SITE PLAN REVIEW AMENDED SUBMISSION
GENERAL NOTES:

OWNERS AGENT:	
PROJECT NO.:	18574
DESIGNED BY:	MAD
DRAWN BY:	MAD
CHECK BY:	JKM
DATE:	11/30/12
SCALE:	1" = 10'
XEMED HOLDINGS LLC	
AMENDED SITE PLAN REVIEW SUBMISSION	
PROPOSED SITE LAYOUT	
C102	
SHEET 2 OF 3

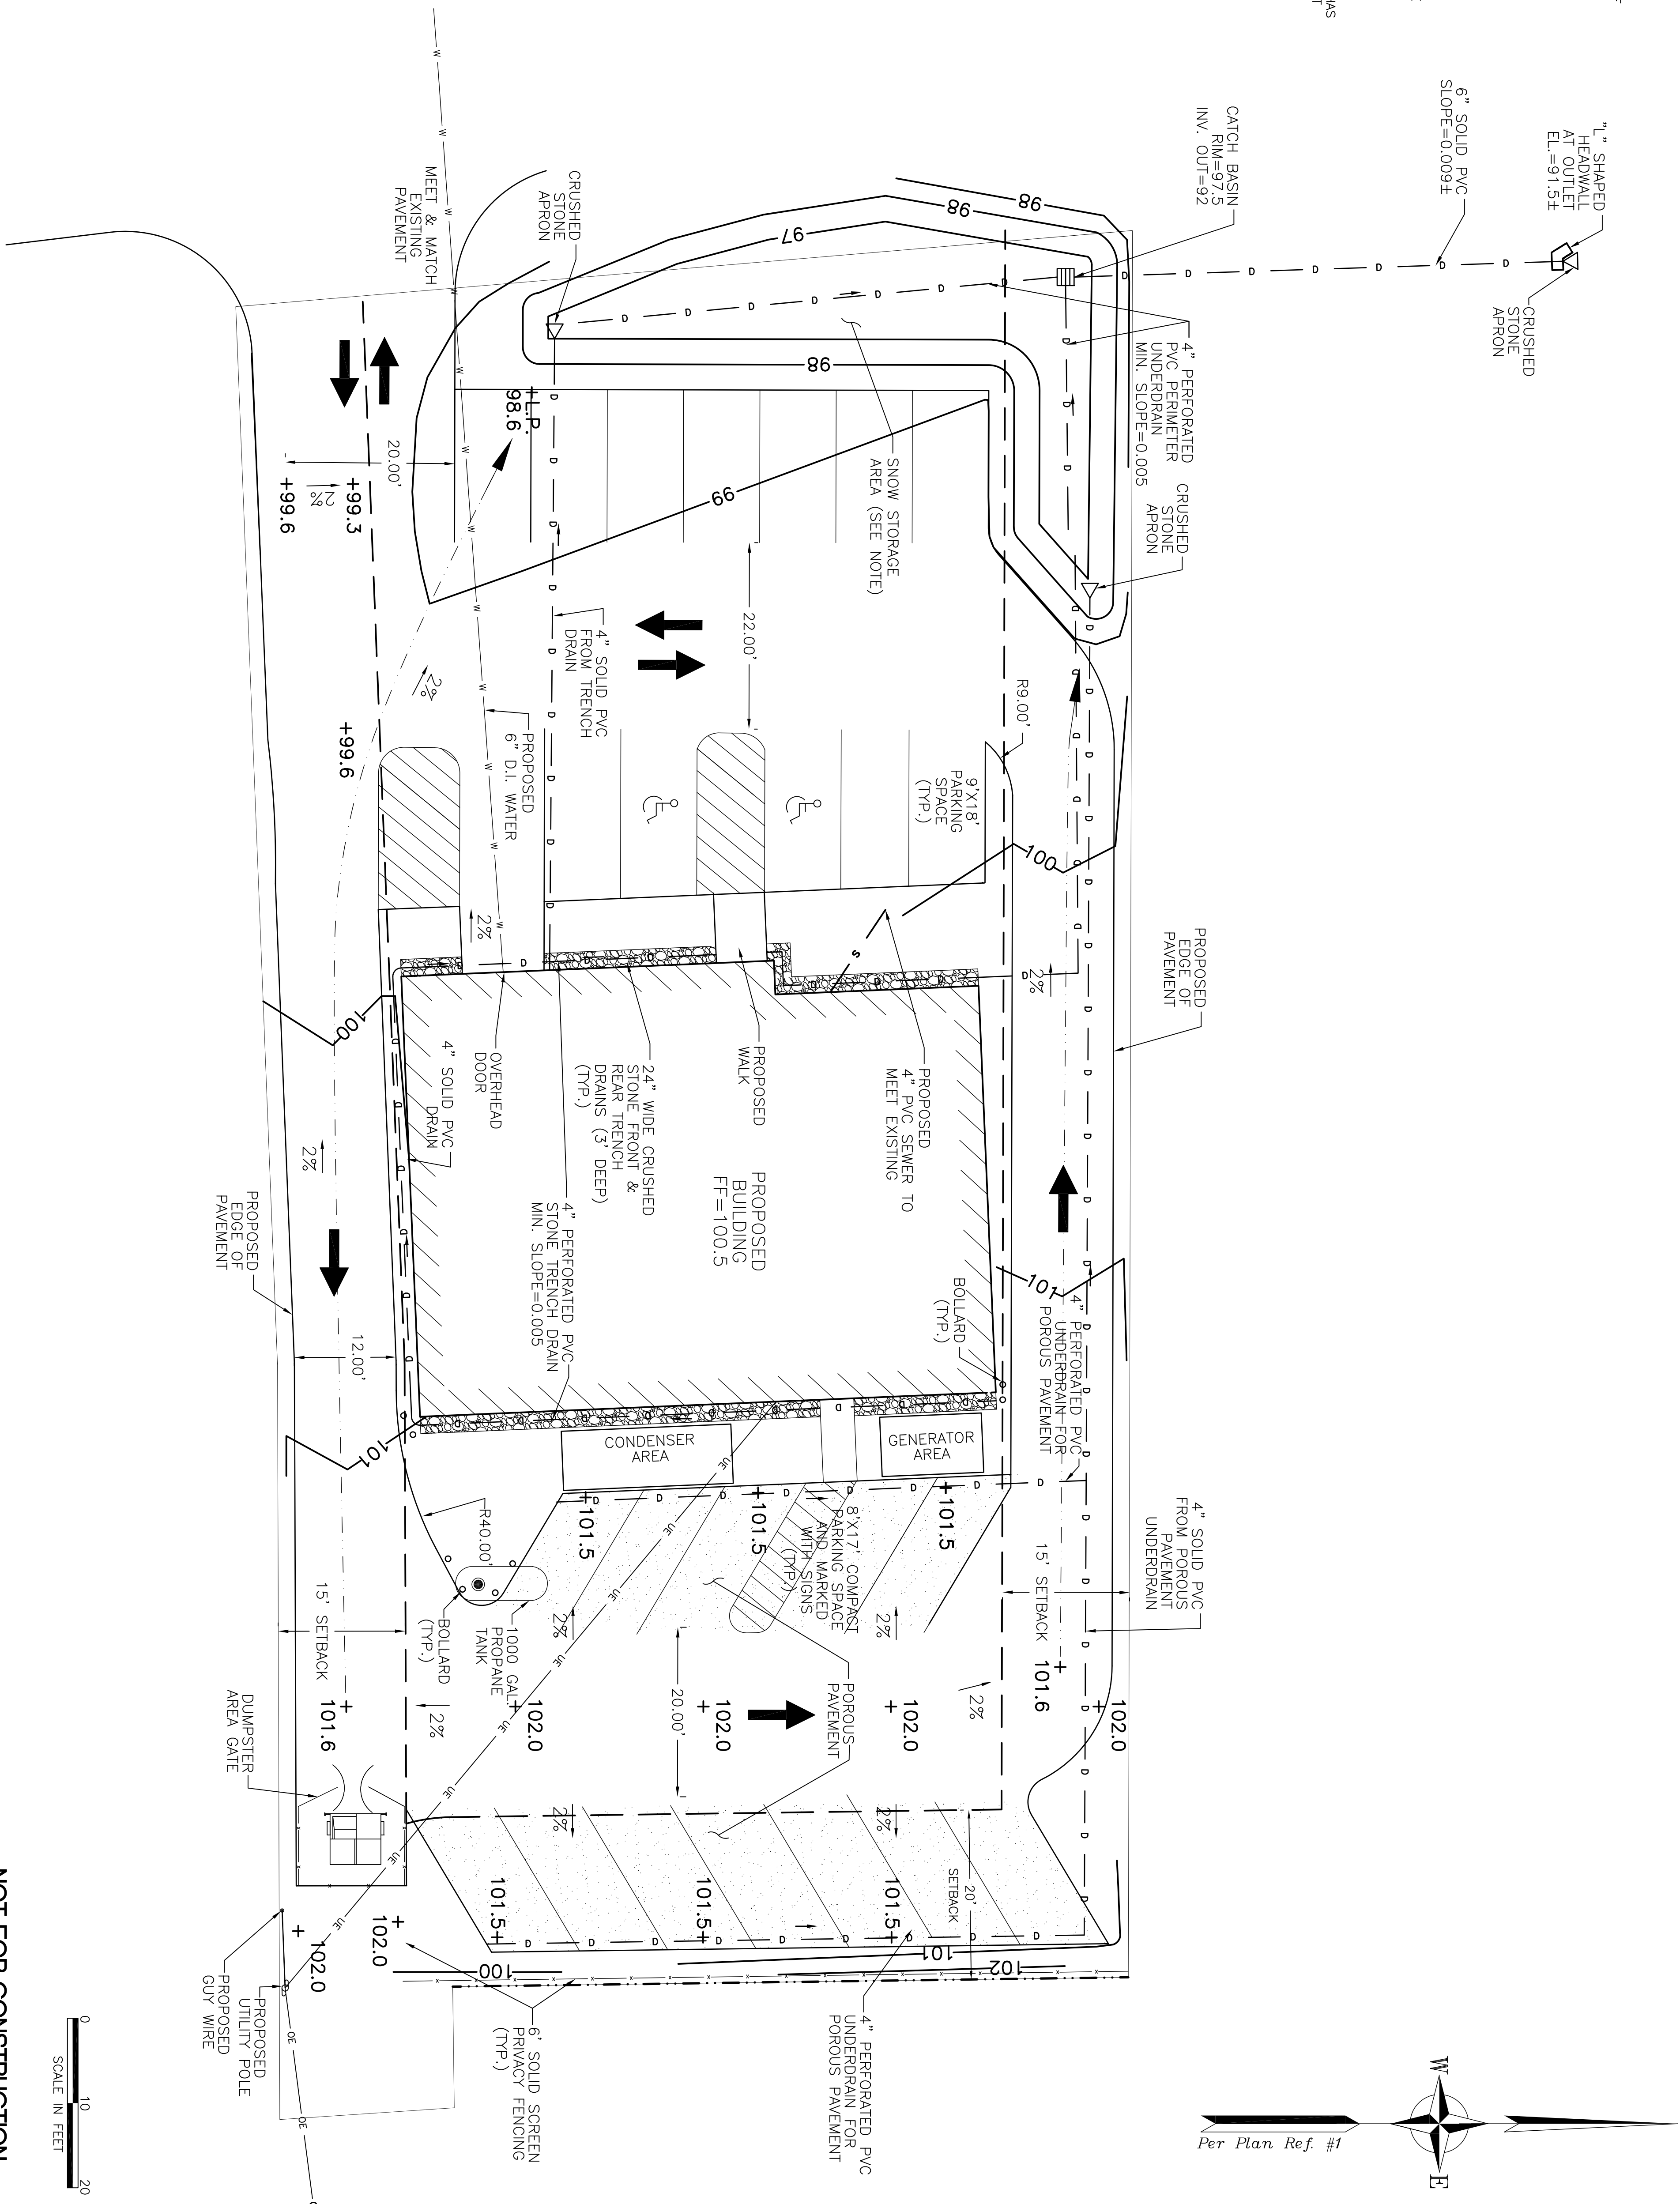
1. THIS PROJECT WAS APPROVED BY THE DURHAM PLANNING BOARD ON FEBRUARY 10, 2010. THESE AMENDED PLANS REFLECT MINOR CHANGES DESCRIBED IN THE ACCOMPANYING LETTER OF INTENT.

6. SINCE THE FEBRUARY 10, 2010 APPROVAL, THE PROPOSED IMPERVIOUS AREA AT THE SITE HAS DECREASED AND LESS RUNOFF IS PRODUCED. THE STORMWATER MANAGEMENT DESIGN HAS NOT CHANGED FROM THE PREVIOUSLY APPROVED "HYDROLOGIC IMPACT ASSESSMENT" REPORT DATED JANUARY 2010.
